Market Change Request

Number		Title	Priority
MCR	0089	Amendments to MPD 5 (New NQH Metered Connection) to satisfy new requirements for SEM Implementation	<i>HIGH</i>

Date	Version	Reason For Change
24/10/2006	1.0	Draft for IGG Review
15/11/2006	1.1	As detailed in "Responses to AIP MCR Comments". Ref. 4, 5, 75

2. ARIS Process Flow Diagram: Supporting Text

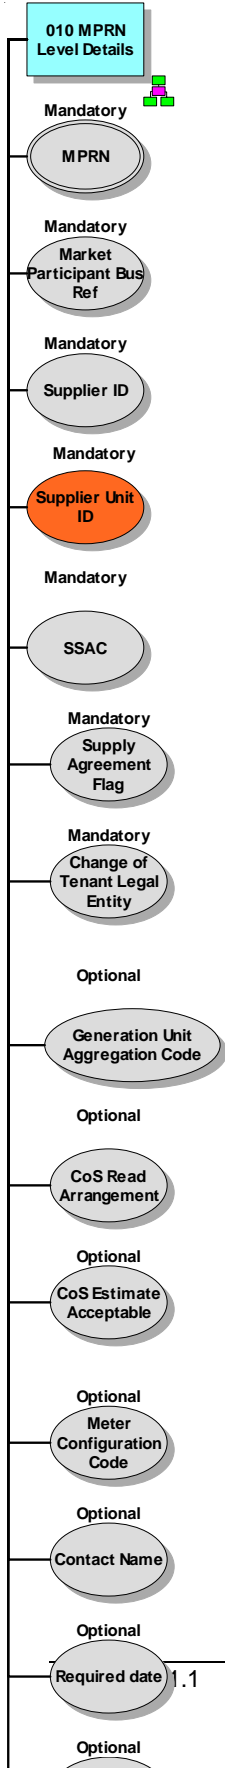
Details of the process where the Description has changed are highlighted in blue below :-

Name	Update Registration Record with Rejection
Description	<p>Failure of the following validations will cause the registration to be rejected.</p> <ul style="list-style-type: none"> • The Supplier must have provided all mandatory information • The MPRN must have been assigned and is not terminated • The Supplier Id is a valid one and the Supplier has a DUoS agreement. • The Supplier must be entitled to register a Meter Point under the legislation and in accordance with the Trading and Settlement Code. • The Supplier warrants that a supply agreement exists with the customer at the Meter Point being registered. • The Supplier must provide a Supplier Unit that is valid for the Supplier. • The Supplier Unit must not be a Trading Site Supplier Unit. • The Supplier must provide a sub-aggregation code (SSAC) that is valid for the Supplier Unit and for the Settlement Class. • EAI must be valid and not blank for sites over 30 kVA <p>If registration is rejected the Supplier is informed of the rejection with the reasons. Failure of the following validation will cause the registration to be rejected unless the DSO approves the new information:</p> <ul style="list-style-type: none"> • Meter Point Address advised by Supplier is materially inconsistent with Meter Point Address known to MRSO. DSO may accept or reject the new address submitted by the Supplier.

3.1 MM010

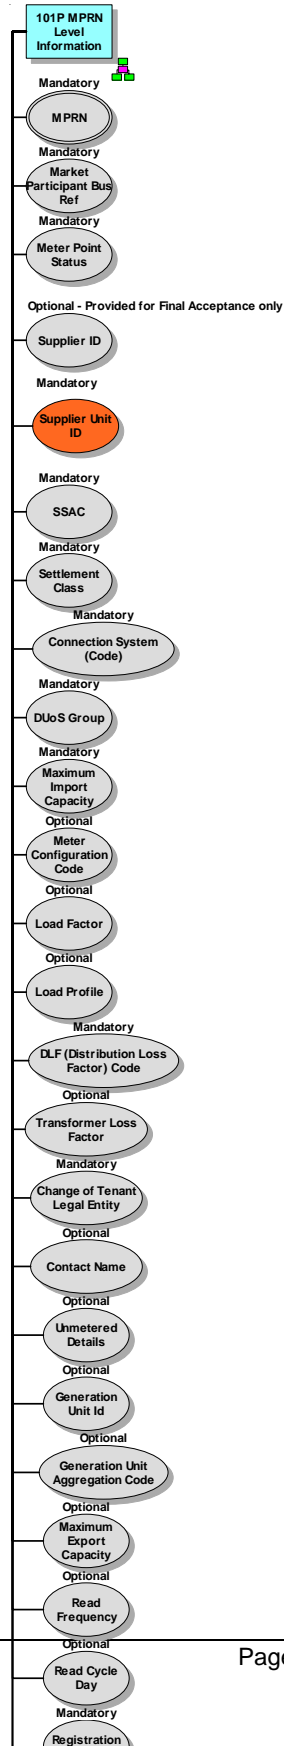
“Supplier Unit ID” will be added to “MPRN Level Details” above “SSAC” in the 101, 101P and 101R Market Messages and Generation Unit ID removed from the 010, as follows:-
